9 Mile PD Amendment/Minor Subdivision Public Hearing Notice

Memo

Public and Infrastructure Plans Comments – 2nd Submittal

INFRASTRUCTURE CONSTRUCTION
DOCUMENTS
NINE MILE CORNER
EVERGREEN DEVCO INC

STORM SEWER BYPASS
PLAN & PROFILE

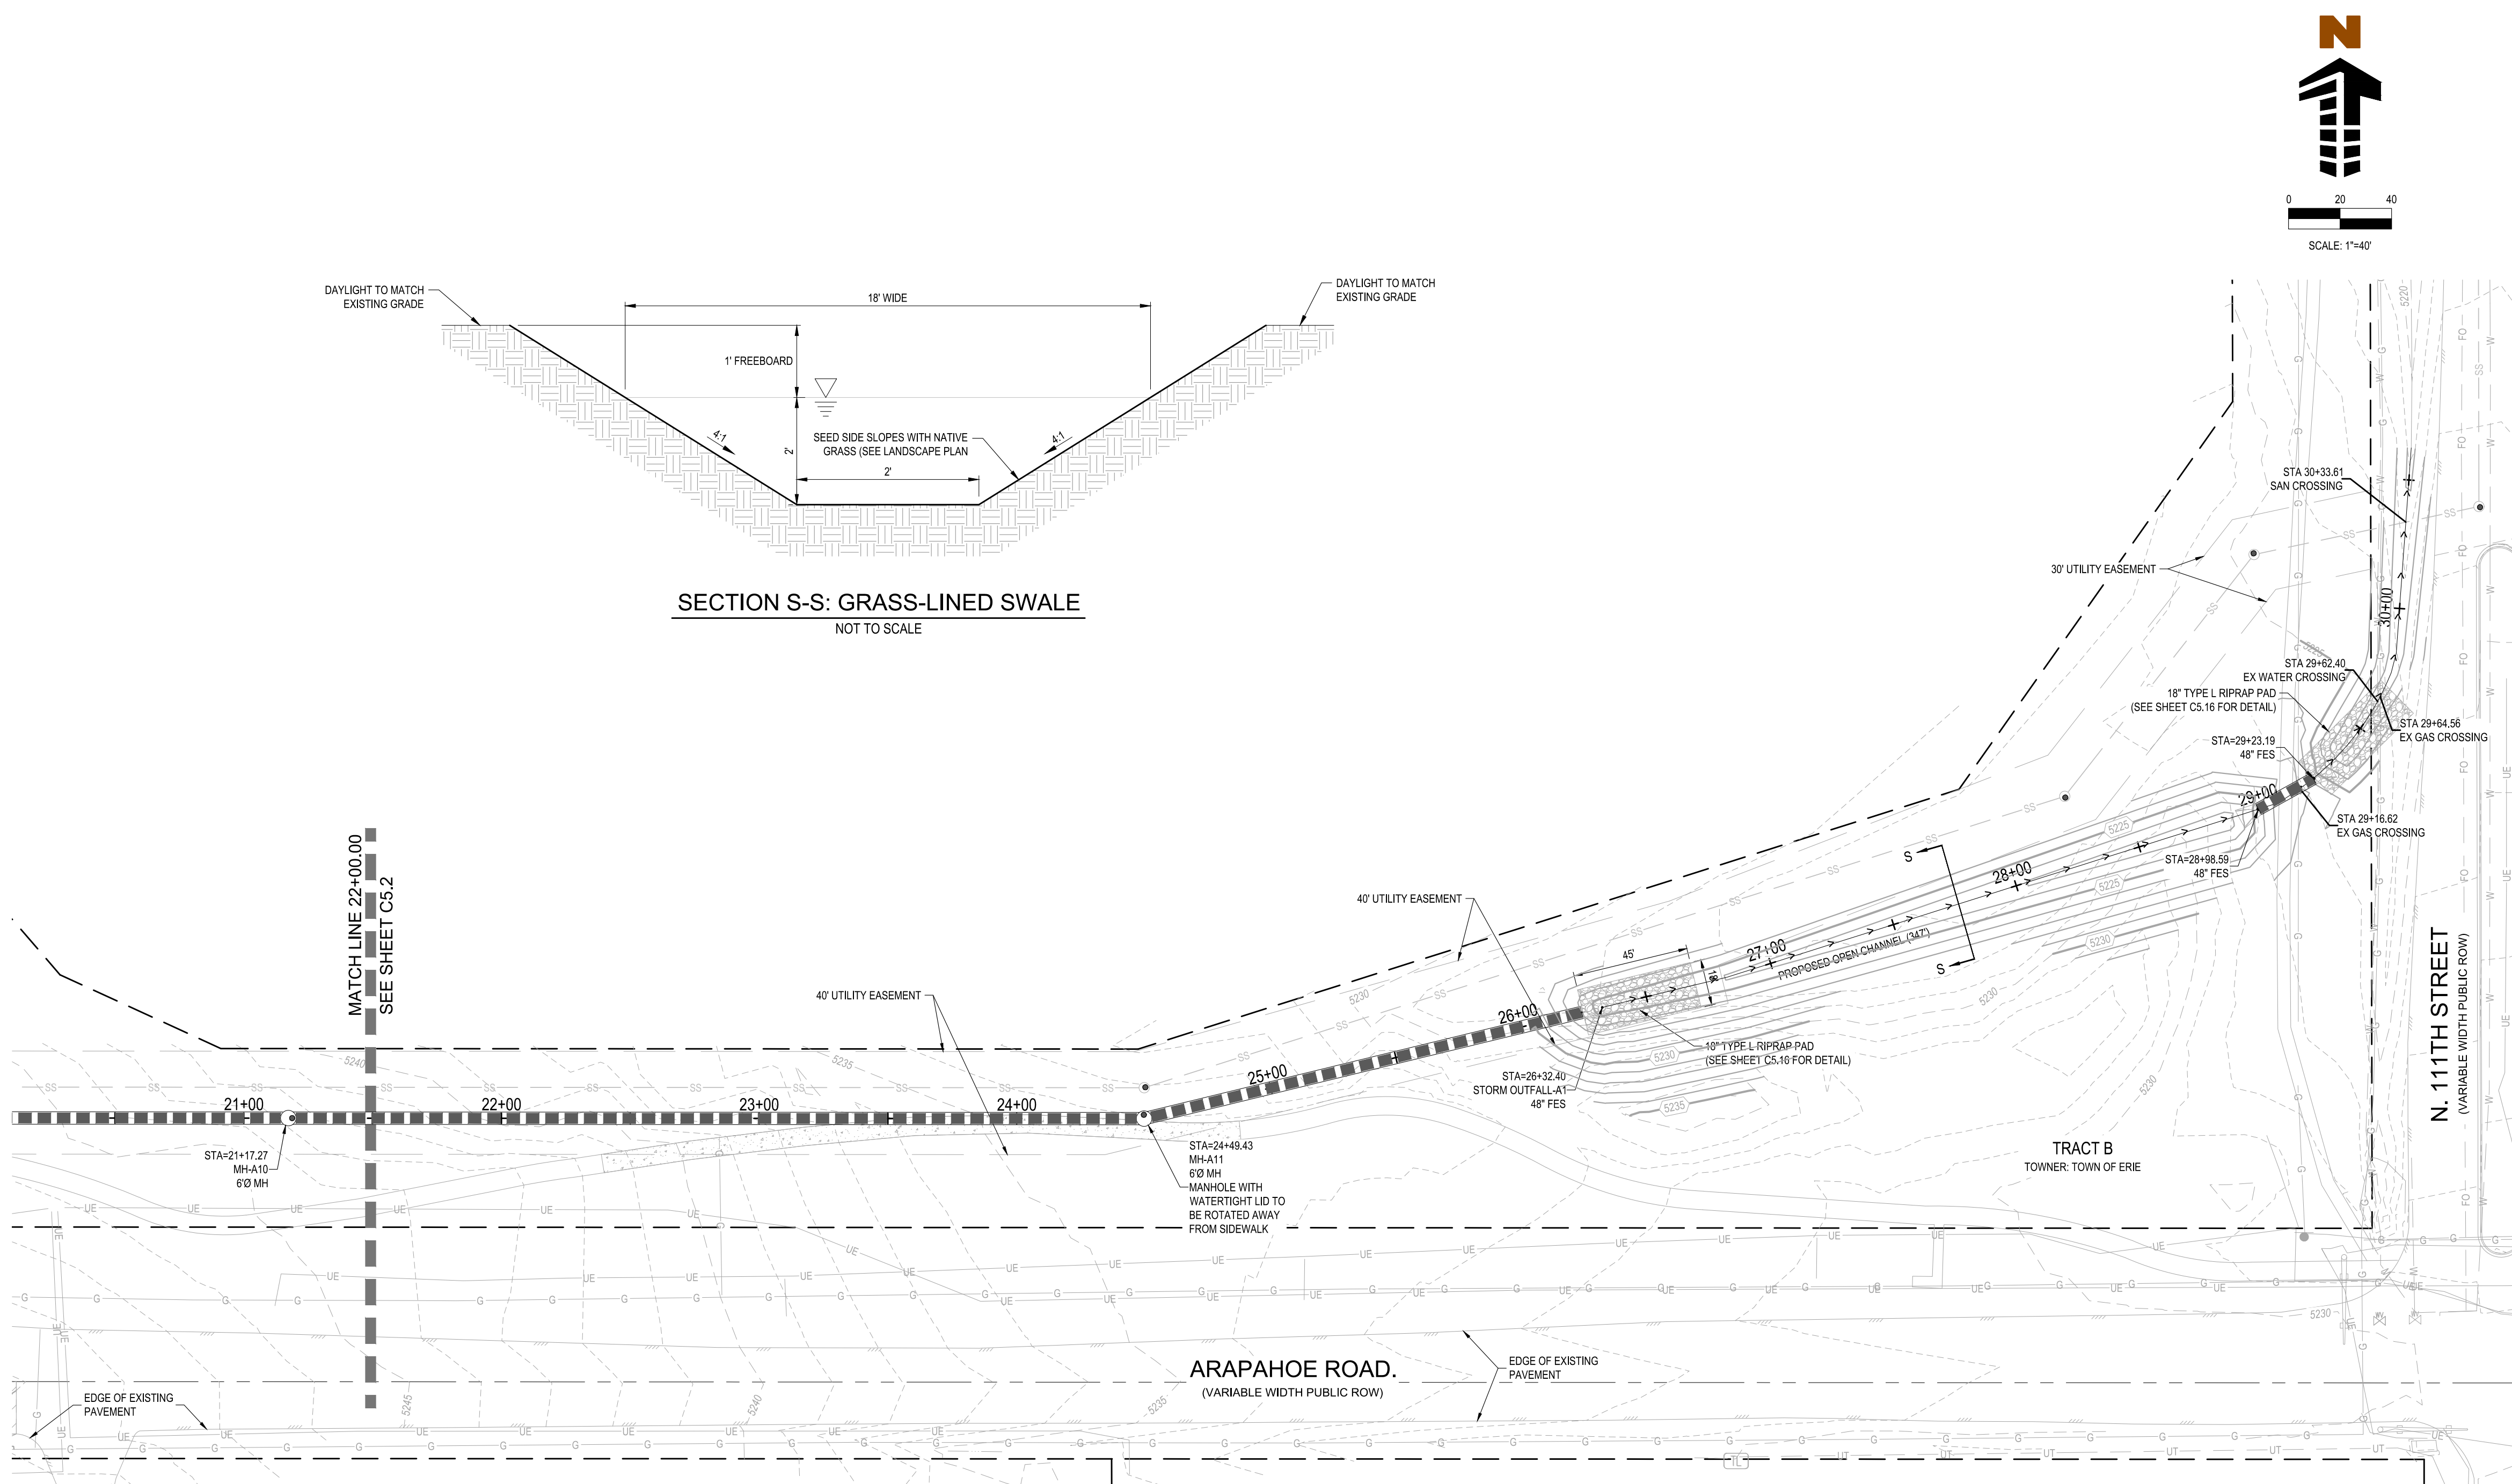
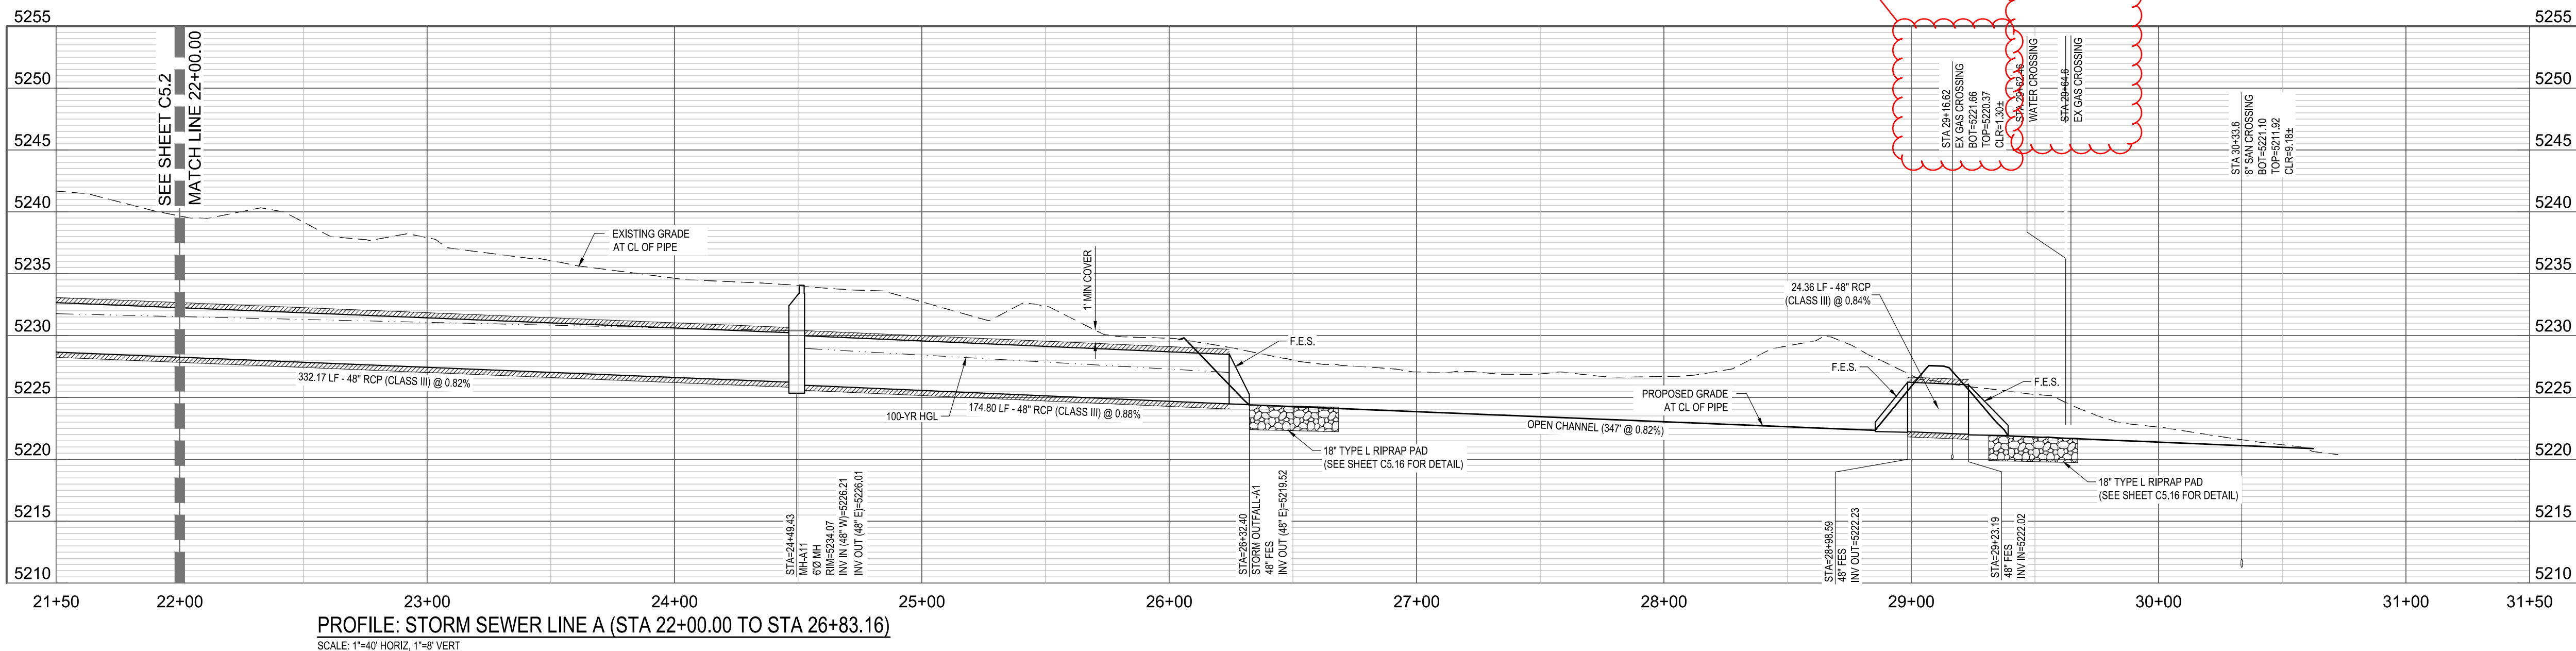
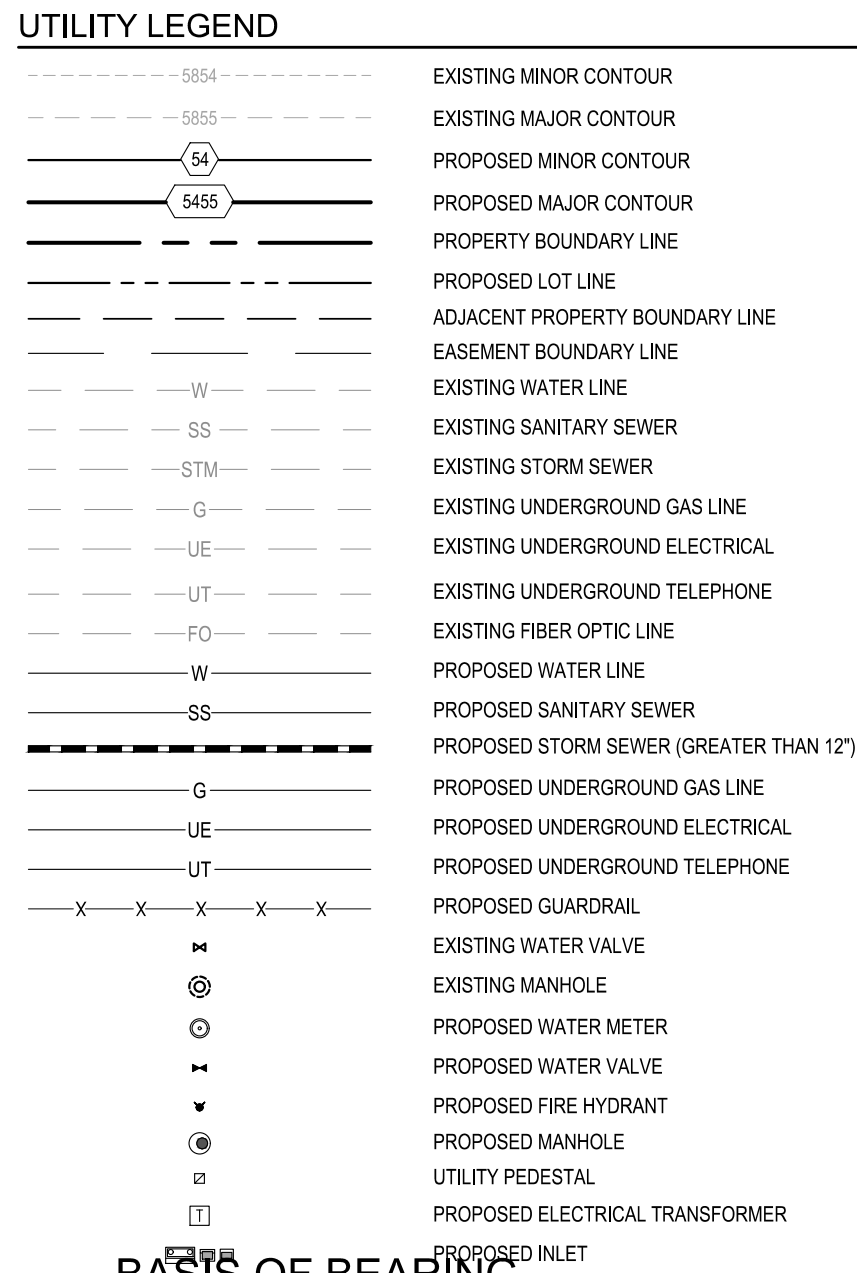
Less than 1.5' Clear. Adjust or
obtain variance from gas line owner.

Show clearance or
relocate as necessary

PLAN: STORM SEWER LINE D (STA 50+00.00 TO STA 60+35.55)
SCALE: 1"=40'

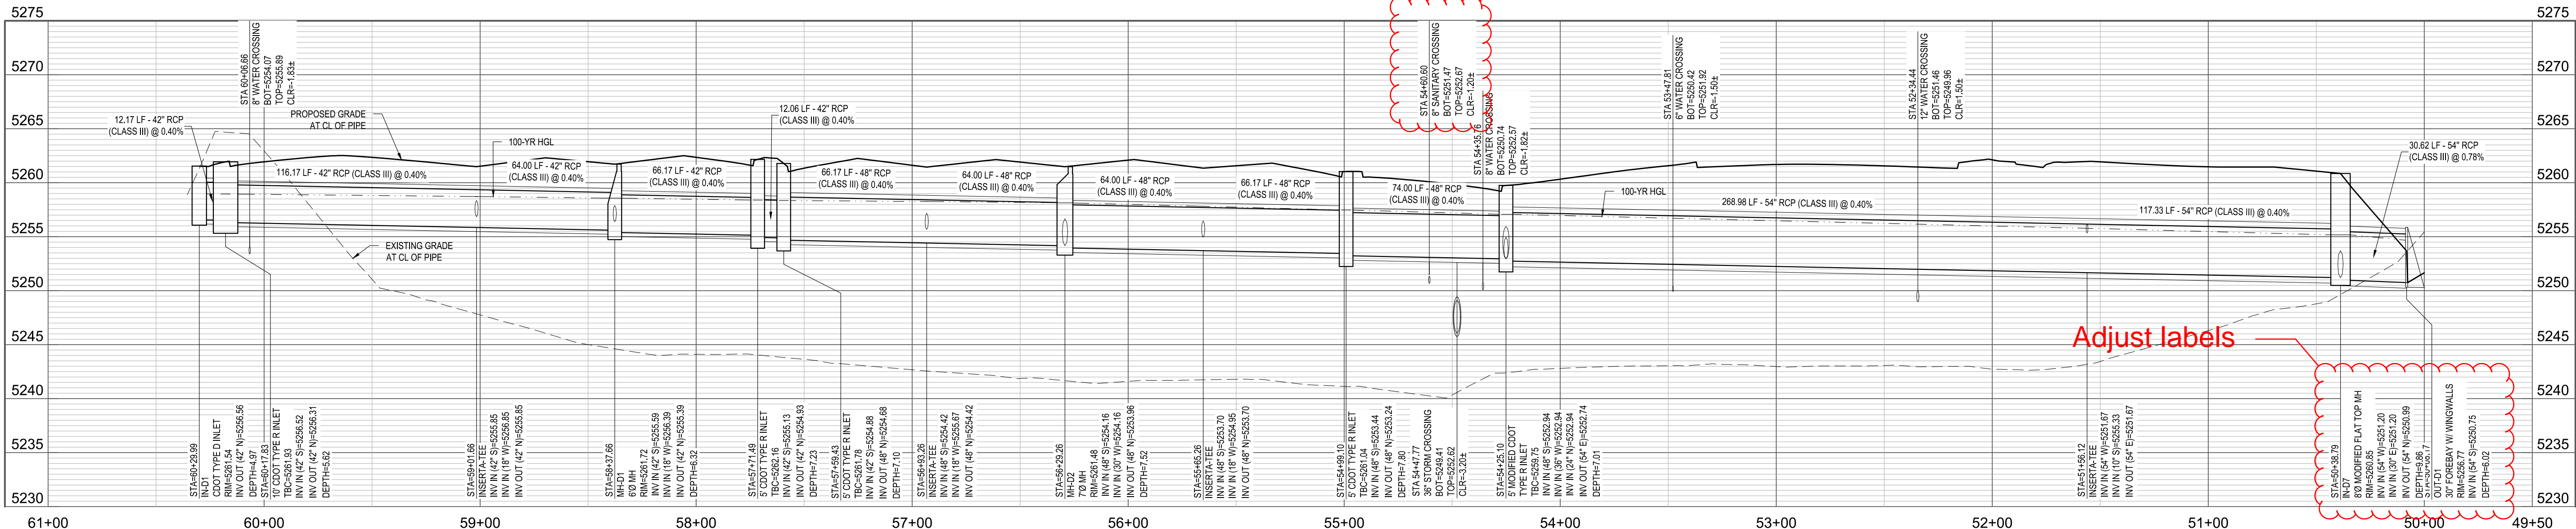
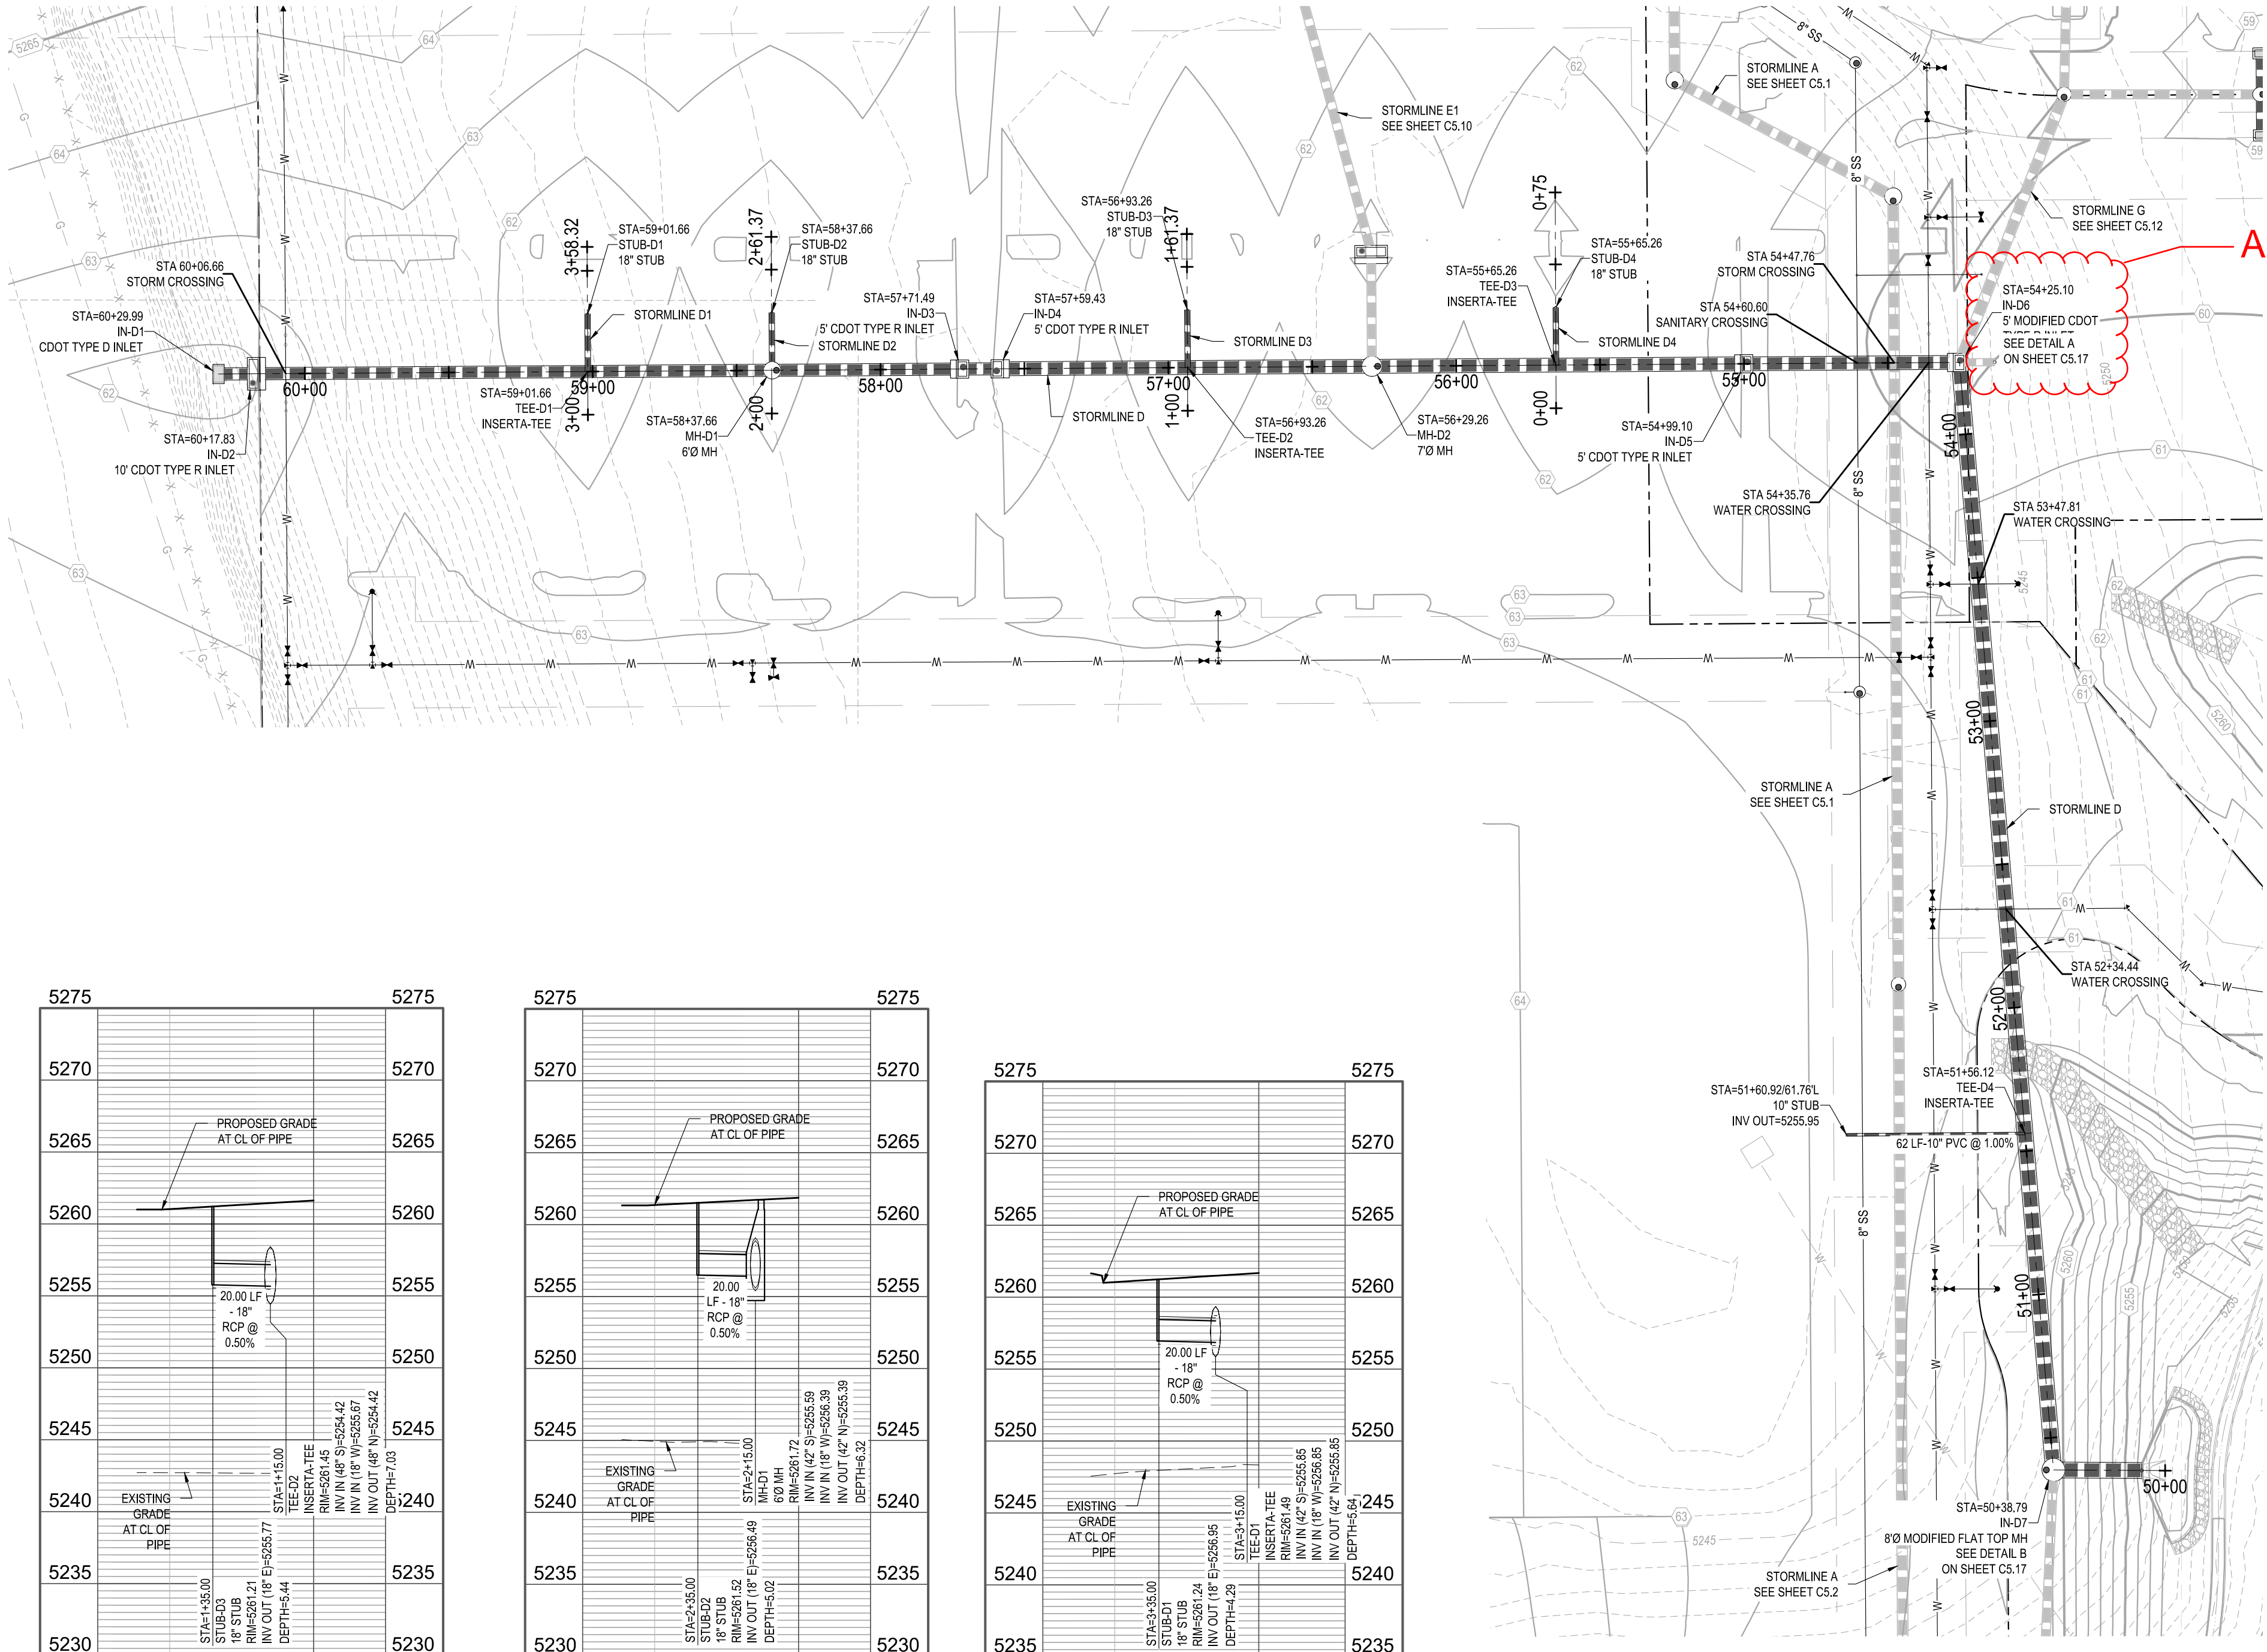
Adjust labels

Add sleeve

Adjust labels
